# Oregon State University

## **HOVLAND HALL WEST WING REMODEL CONSTRUCTION SERVICES**

### **ADDENDUM NO. 2**

## Addendum # 03

FIRST FLOOR PLAN AND  
RCP

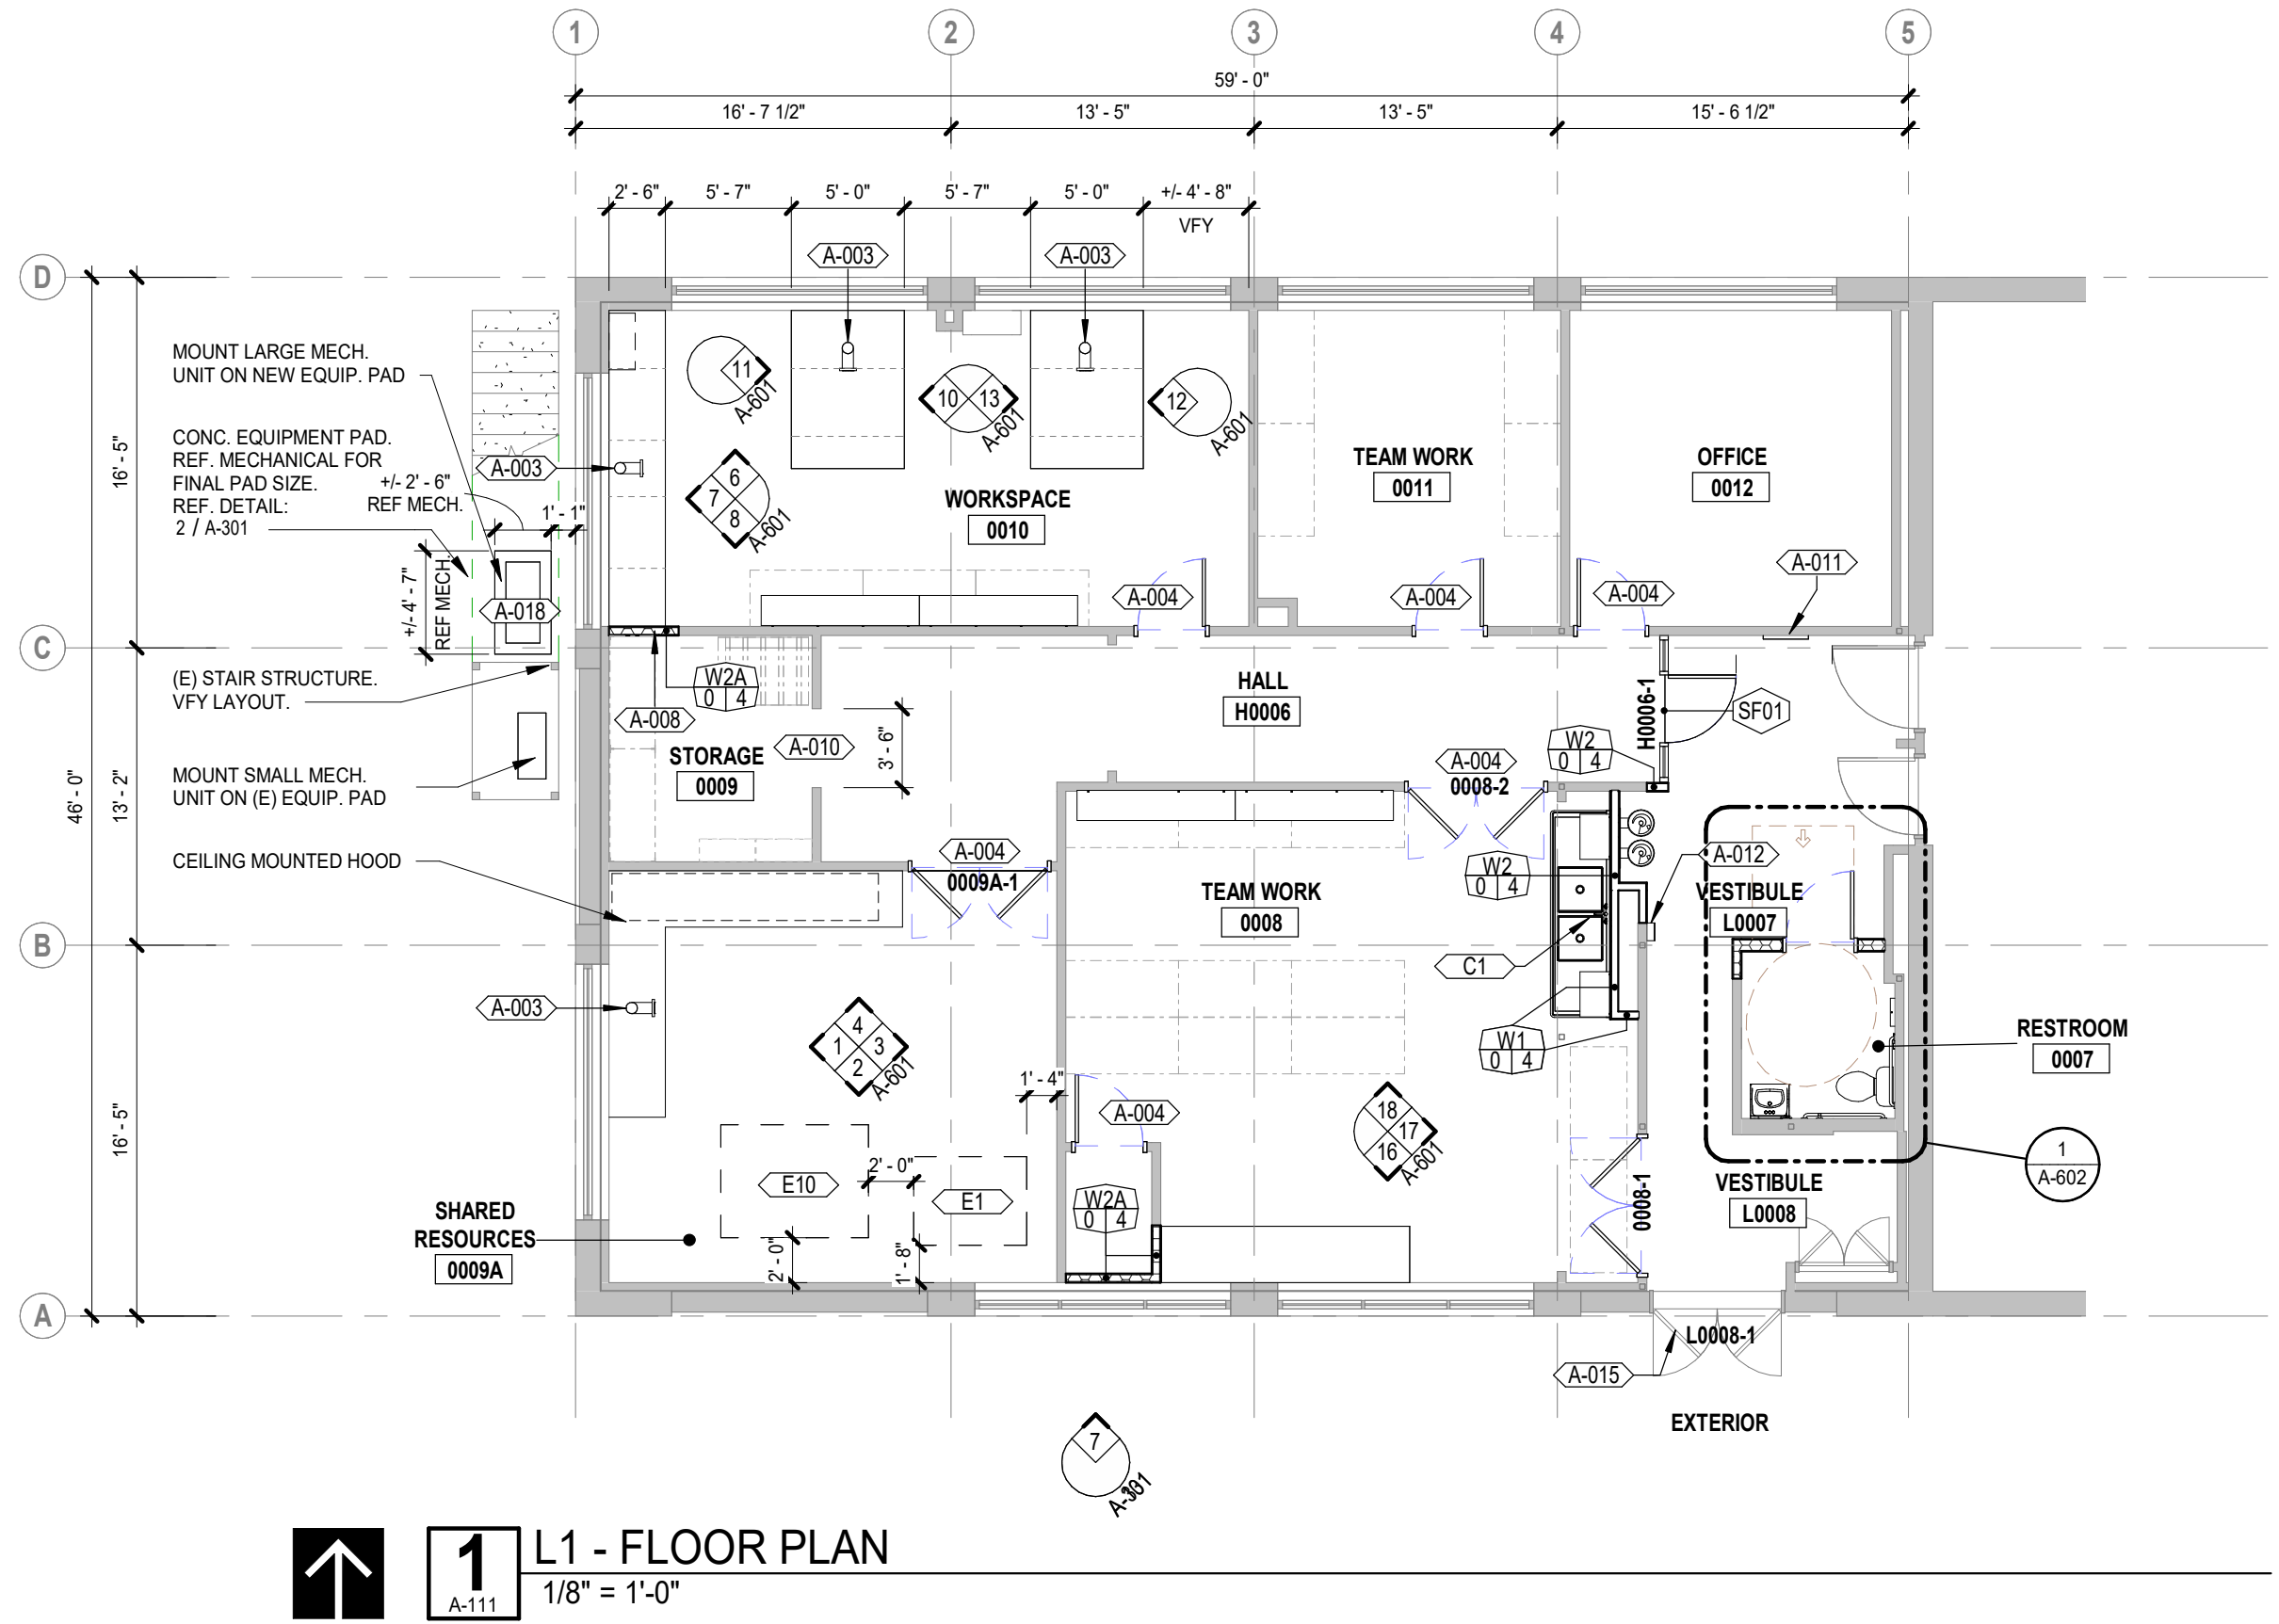
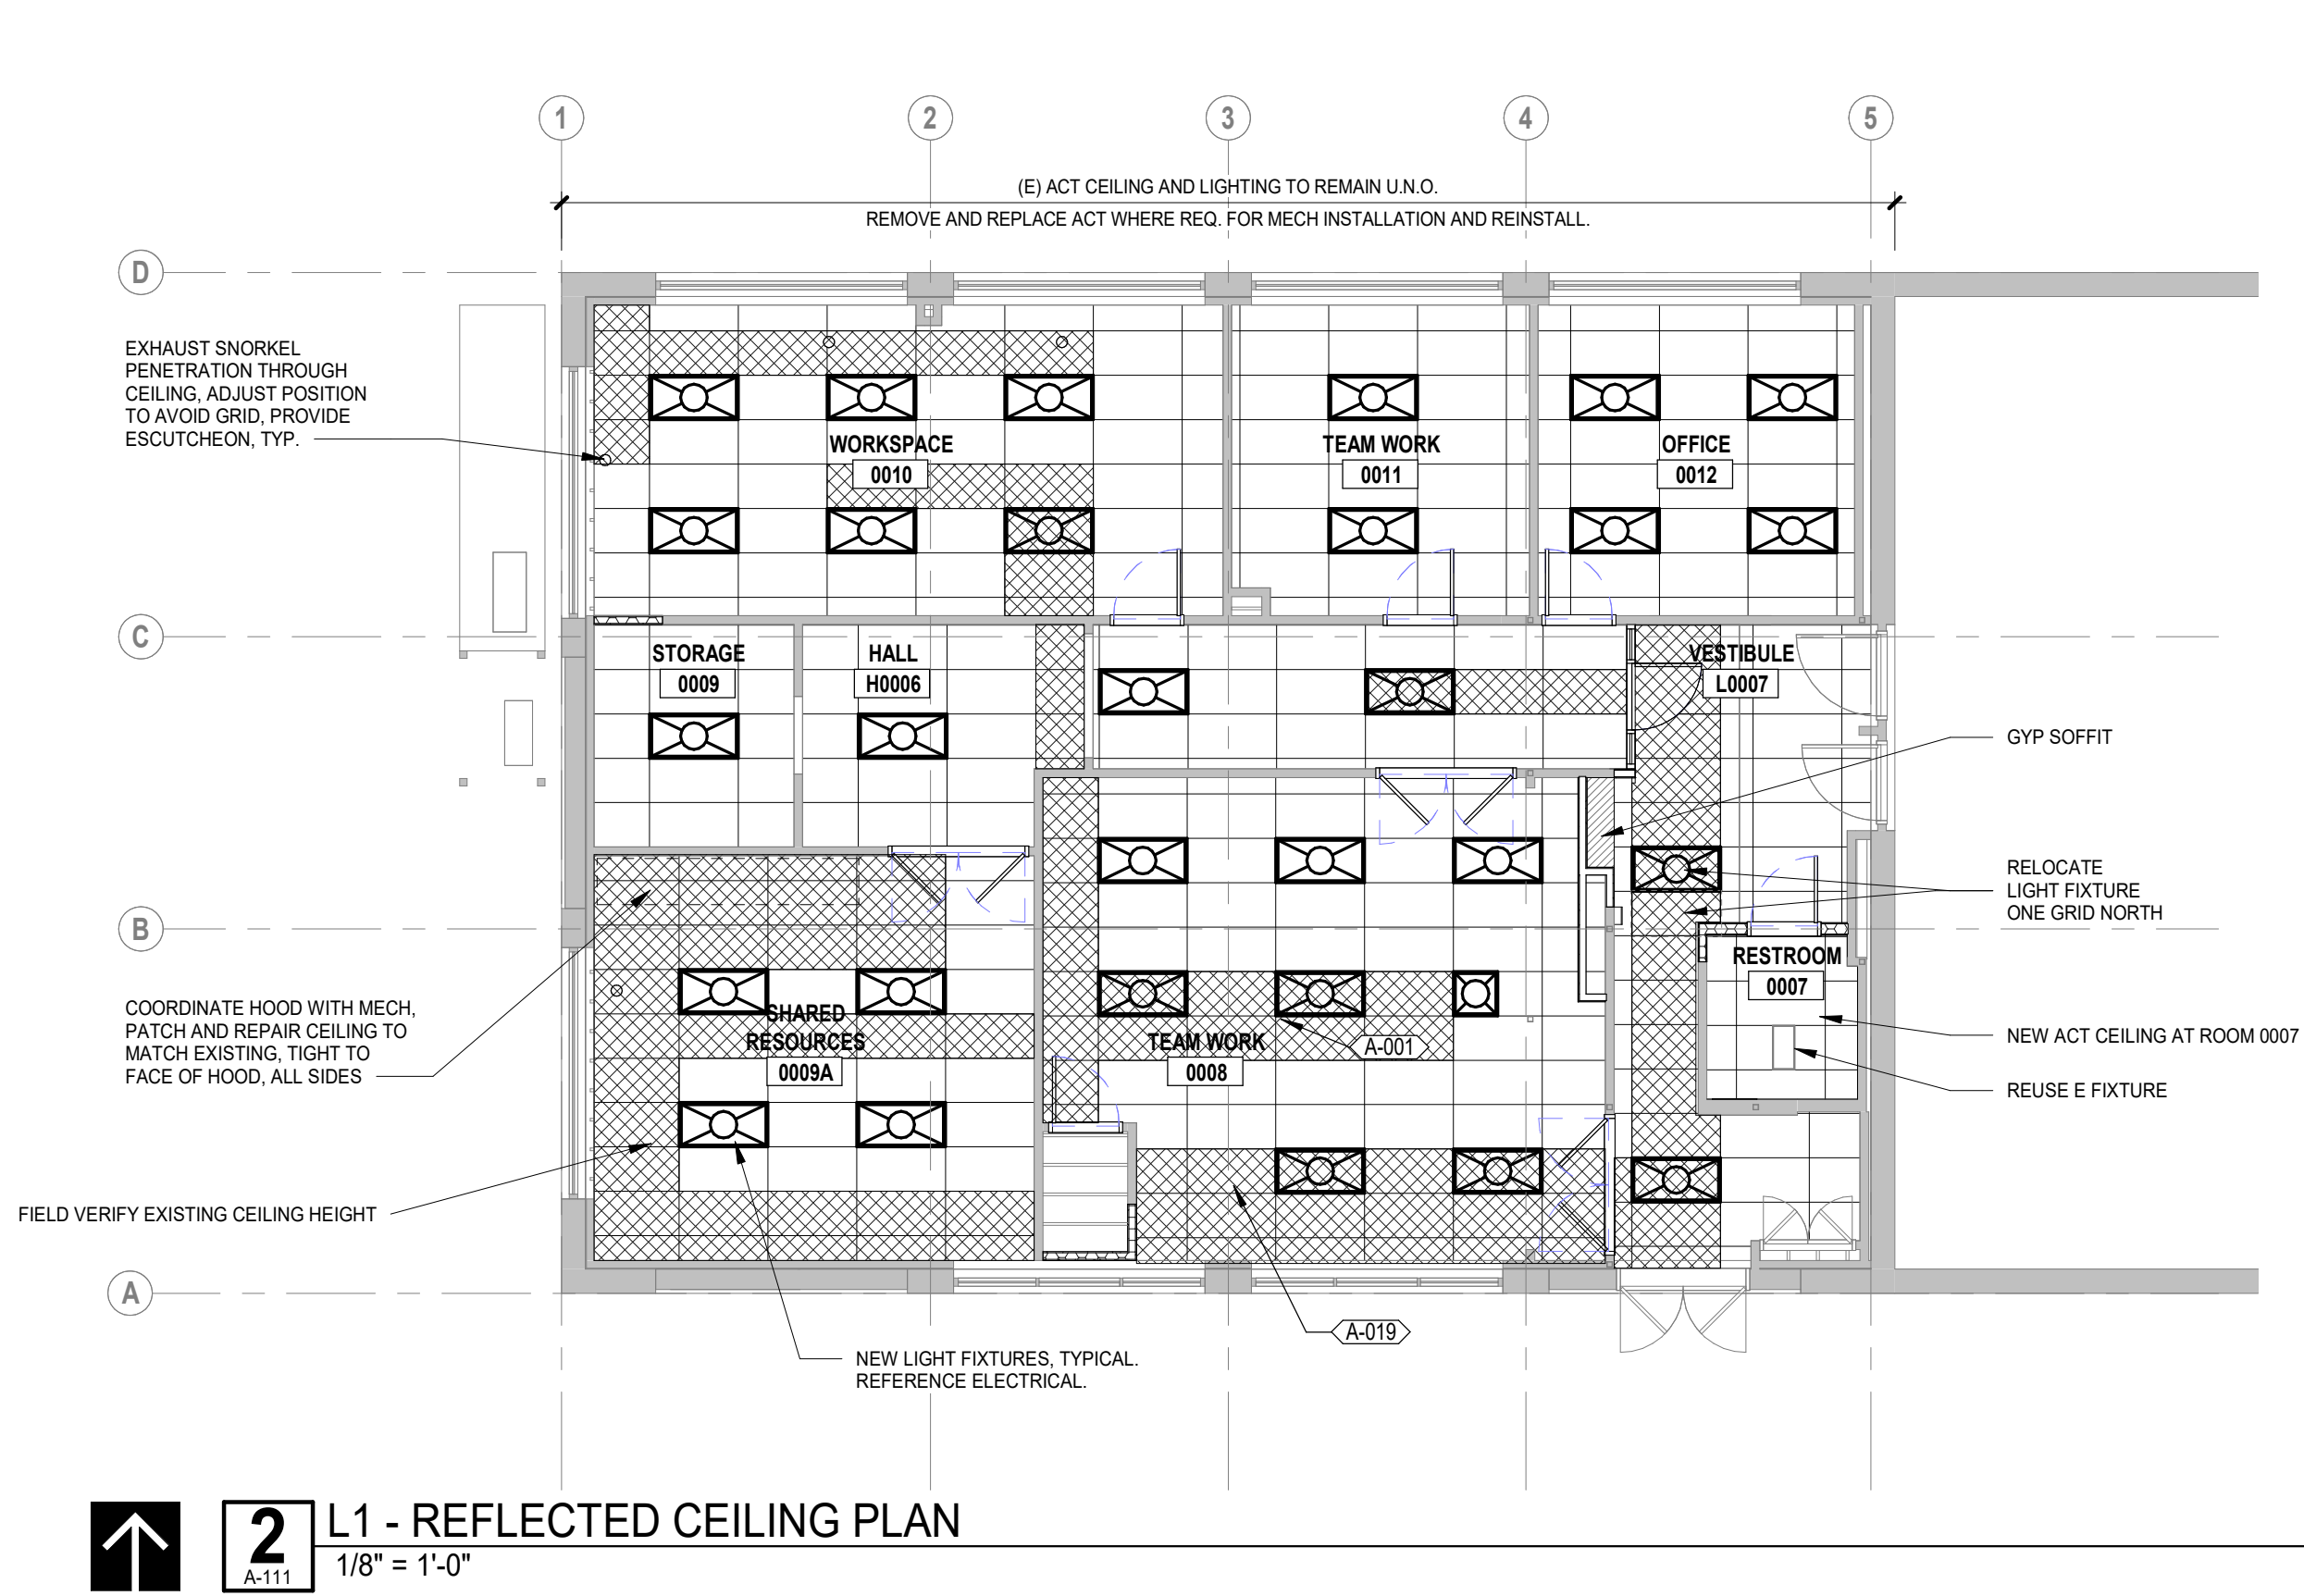
- 5) Sheet A-001 (re-issued, attached). Revisions include:
  - a) Framing size notes revised as shown.
  - b) Wall type W1 / W1A added as shown.
  - c) Drawing #3 Suspended ACT Diagram added as shown.
- 6) Sheet A-111 (re-issued, attached). Revisions include:
  - a) Keynotes A-005, A-006 and C1 revised as shown.
- 7) Sheet A-601 (re-issued, attached). Revisions include:
  - a) Keynotes revised as shown.
  - b) Elevation 17 revised as shown.
- 8) Sheet P-002 (re-issued, attached). Revisions include:

*Question: 3/A-111 indicates floor leveling and concrete pourback. Is there an available estimated slope grade % to trenches for quantifying floor leveler?*

*Question: Will trenches (Keynote A-006/A-111) require de-commissioning and infill as well?*

**Response:** Please see revised keynotes A-005 and A-006 on A-111. Finished floor slopes should be installed to ¼" per foot max. Existing trench drains can be assumed to be -4" below the finish floor elevation, for the purpose of estimating floor levelling amounts. This shall be field verified by the Contractor.

**Response:** Please see revised keynote A-006 on A-111. Existing trenches have been decommissioned and filled. However, the Contractor shall plug any existing drains which are exposed during below-slab work.

A-006	LOCATION OF EXISTING TRENCH DRAIN PER ORIGINAL AS-BUILTS. ANTICIPATED SLAB LOW POINT. ASSUME EXISTING TRENCH DRAINS ARE 4" BELOW FINISH FLOOR FOR ESTIMATING PURPOSES. FIELD VERIFY.
A-007	LEVEL FLOOR TO EXISTING DOOR OPENING LOCATION. TAPER AS REQUIRED TO MEET EXISTING THRESHOLD OR TRANSITION HEIGHT.
A-008	INFILL EXISTING WALL OPENING. VERIFY EXISTING WALL THICKNESS AND FRAME TO MATCH. PATCH FINISHES TO MATCH EXISTING.
A-010	NEW OPENING IN EXISTING WALL. 7' TALL. PROVIDE NEW 4X8 HEADER AND 1 TRIMMER STUD + 1 KING STUD EA. END. FINISH TO MATCH EXISTING WALL.
A-011	REINSTALL EXISTING AED DEVICE. PROVIDE FURRED WALL MIN. 2" DEEP FROM FLOOR UP TO BOTTOM OF DEVICE.
A-012	NEW RECESSED FIRE EXTINGUISHER CABINET IN EXISTING WALL. RECESS INTO EXISTING WALL CAVITY. VERIFY AND CONFIRM NO CONFLICTS WITHIN EXISTING WALL CAVITY.
A-015	ELECTRICAL SUBCONTRACTOR SHALL ADJUST AUTOMATIC DOOR OPENING MECHANISM FOR CORRECT OPERATION. DOOR SHALL REOPEN AFTER ENCOUNTERING OBSTRUCTION. BY OTHERS, REF ELECTRICAL.

A-021	PLUG OPEN ENDS OF EXISTING TRENCH DRAIN WHERE EXPOSED DURING UNDERSLAB WORK. (E) TRENCH DRAIN IS FILLED WITH CONCRETE. BUT SOME OPEN DRAIN LINE MAY REMAIN. FIELD VERIFY AND PLUG ABANDONED TRENCH DRAIN WHERE UNCOVERED.
C1	STAINLESS SINK, 2 BASIN, 2 FAUCETS, DRAINBOARDS, FULL LENGTH INTEGRATED SHELF BELOW DRAINBOARDS/BASINS. CUSTOM/ CONTRACTOR FURNISHED AND INSTALLED. REFERENCE PLUMBING.
